**STAFF REPORT**  
(Final Plat, Preliminary Plat Approved 10/15/09)

**CASE NUMBER:** SUB 2009-63 -- STEVE KELLEY 6<sup>TH</sup> ADDITION

**STAFF REPORT**  
**(Preliminary Plat)**

**SUB 2009-63 -- Preliminary Plat of STEVE KELLEY 6<sup>TH</sup> ADDITION**  
**October 15, 2009 - Page 3**

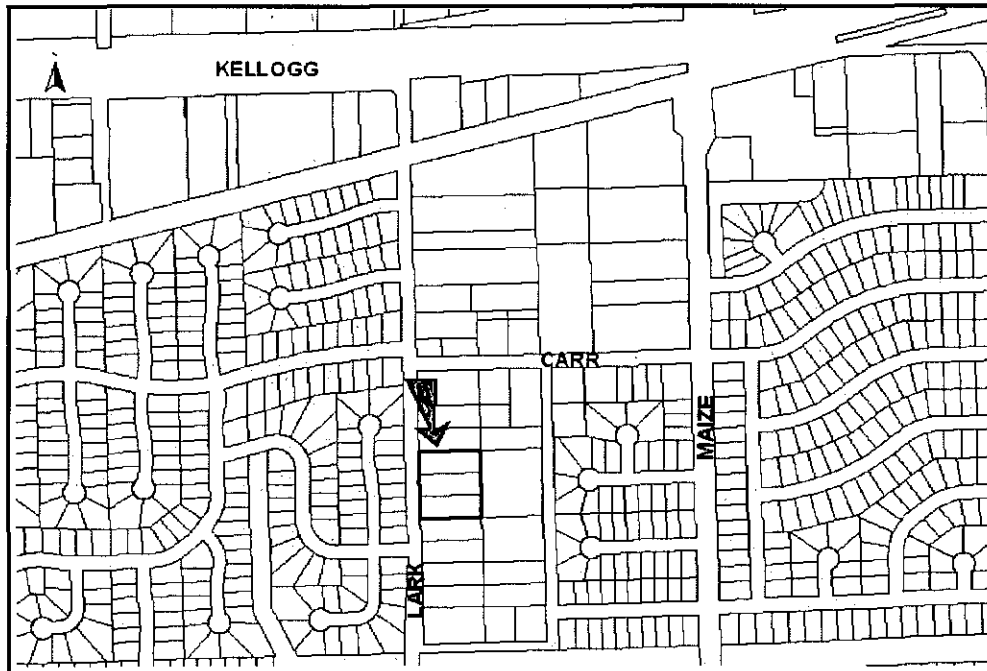
- A. City of Wichita Water Utilities Department requests a petition for water (transmission and distribution mains) and sewer (mains and laterals) to serve all lots being platted.

- B. If improvements are guaranteed by petition(s), a notarized certificate listing the petition(s) shall be submitted to the Planning Department for recording.

- C. City Stormwater Engineering needs to comment on the applicant's drainage plan.
- D. The Applicant shall guarantee the paving of the proposed street.

- E. *Since this plat proposes the platting of narrow street right-of-way with adjacent 15-foot street drainage and utility easements, a restrictive covenant shall be submitted which calls out restrictions for lot-owner use of these easements. Retaining walls and change of grade shall be prohibited within these easements as well as fences, earth berms and mass plantings.*

- F. The applicant shall submit a covenant that provides four (4) off-street parking spaces per lot that abuts a 32-foot street. The covenant shall inventory the affected lots by lot and block number and shall state that the covenant runs with the land and is binding on future owners and assigns.

- G. GIS has approved the plat's street name.
- H. The plat's text shall include language that a drainage plan has been developed for the plat and that all drainage easements, rights-of-way, or reserves shall remain at established grades or as modified with the approval of the applicable City or County Engineer, and unobstructed to allow for the conveyance of stormwater.

- I. The applicant shall install or guarantee the installation of all utilities and facilities that are applicable and described in Article 8 of the MAPC Subdivision Regulations. (Water service and fire hydrants required by Article 8 for fire protection shall be as per the direction and approval of the Chief of the Fire Department.)

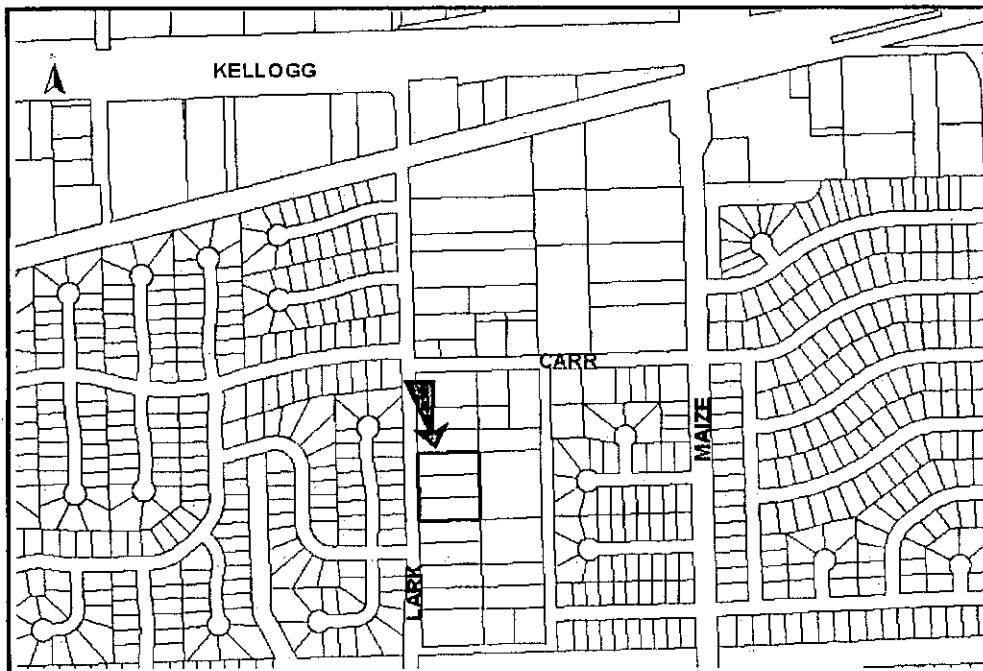
- A. City of Wichita Water Utilities Department requests a petition for water (transmission and distribution mains) and sewer (mains and laterals) to serve all lots being platted.

- C. City Stormwater Engineering needs to comment on the status of the applicant's drainage concept.
- D. The Applicant shall guarantee the paving of the proposed street.

- E. Since this plat proposes the platting of narrow street right-of-way with adjacent 15-foot street drainage and utility easements, a restrictive covenant shall be submitted which calls out restrictions for lot-owner use of these easements. Retaining walls and change of grade shall be prohibited within these easements as well as fences, earth berms and mass plantings.

- F. The applicant shall submit a covenant that provides four (4) off-street parking spaces per lot that abuts a 32-foot street. The covenant shall inventory the affected lots by lot and block number and shall state that the covenant runs with the land and is binding on future owners and assigns.

- G. On the final plat tracing, the MAPC signature block needs to reference "G. Nelson Van Fleet" as Chairman.
- H. Lot 3 and 4 do not appear to conform to the 50-foot lot width standard which is measured at the building setback line. An increase in the distance of the building setback from the road would meet the standard. In the alternative, a modification may be granted by MAPC.

- K. The platting text shall include language that a drainage plan has been developed for the plat and that all drainage easements, rights-of-way, or reserves shall remain at established grades or as modified with the approval of the applicable City or County Engineer, and unobstructed to allow for the conveyance of stormwater.
